Inspector Concerns

Revised Scheme

Plan B Revised proposals

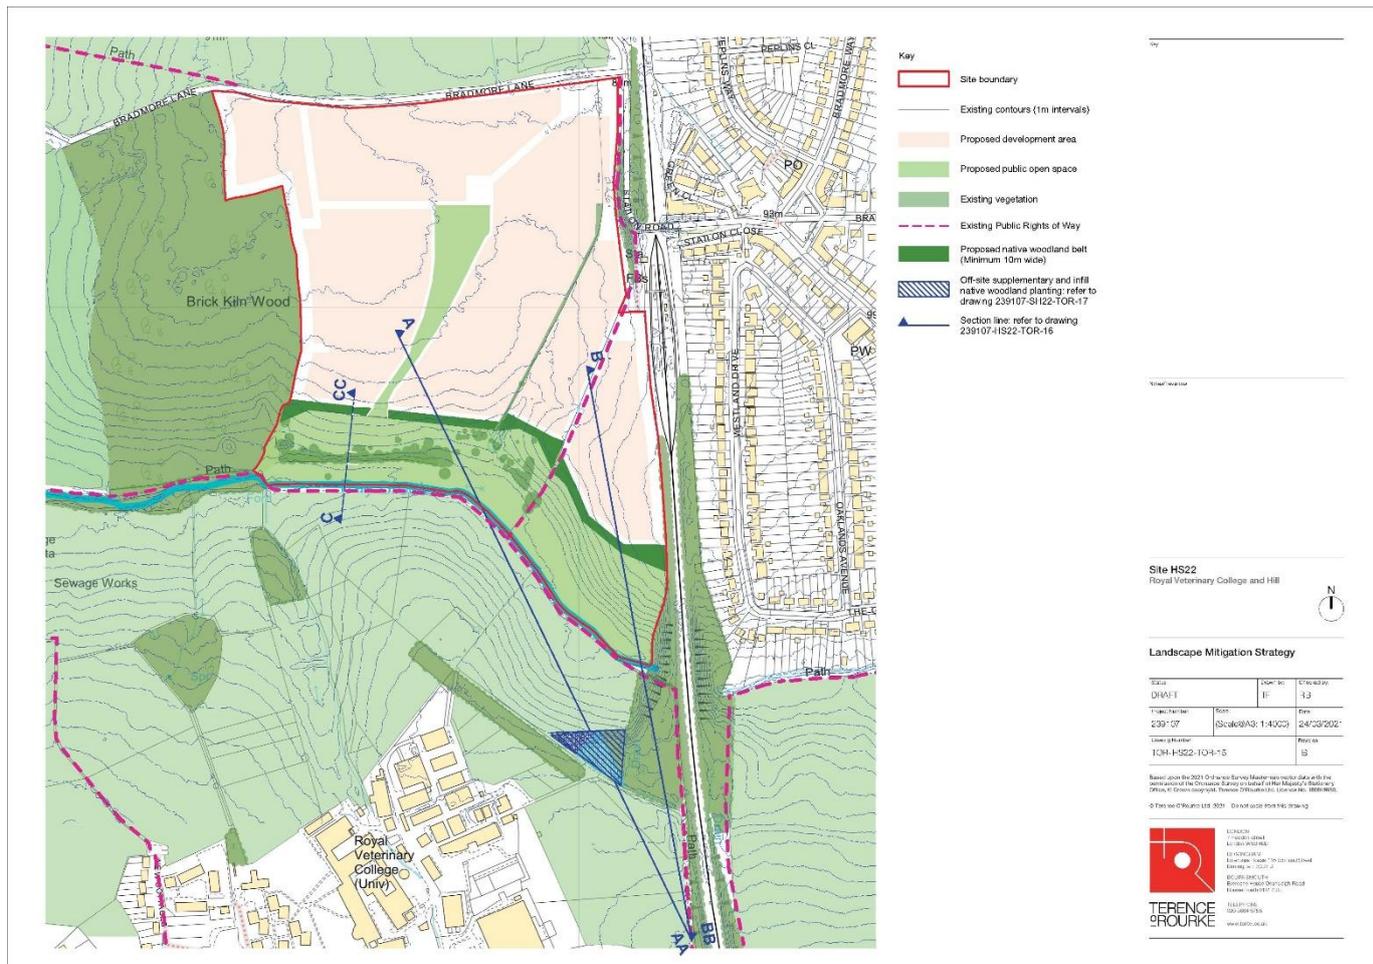
At the hearing session the Inspector requested further information with regards the residual views from the south/south east. He requested further consideration of whether more substantial planting was required to assist him in considering the site.

As noted by the Inspector there is a gap in the existing tree belt (approx. 10m wide) where the site could be viewed from public footpath North Mymms 011 through the gap between the RVC owned and managed tree belts. It is proposed to strengthen the existing planting within the RVC land through a combination of infill tree planting and a new wooded copse immediately to the west of the existing tree belt. The new planting on the RVC land will comprise native woodland species and include climax trees such as oak. This will ensure that the current 'gap' is closed off, resulting in a continuous tree belt that screens views towards the site from public footpath North Mymms 011.

New planting, comprising native woodland species mix, will form a continuous tree belt along the south edge of the development. In combination with the existing planting to the south this new planting will afford a high level of visual containment, alongside additional biodiversity and landscape benefits.

- The development edge has been pulled back from the southern edge of the site to ensure sufficient room is available for a significant belt of new planting on the upper slopes of the local valley.

- A new tree belt along the southern edge is proposed between the development zone and wider countryside. This will include a new earth bunding in the order of 1.75m-2m high, planting with a mix of woodland species no less than 10m wide.

- Planting within RVC land to the south will supplement the existing vegetation with infill woodland tree species and include a new wooded copse to the west, which will further strengthen the visual containment of the valley landscape.

- Cross sections have been prepared to indicate the screening potential of these proposals. These show that views from footpath North Mymms 011 alongside the railway to the west of the site will be of the tree screen and the dwellings will not be visible once the new planting is 10m or higher. The cross sections are in Annex A to this addendum.
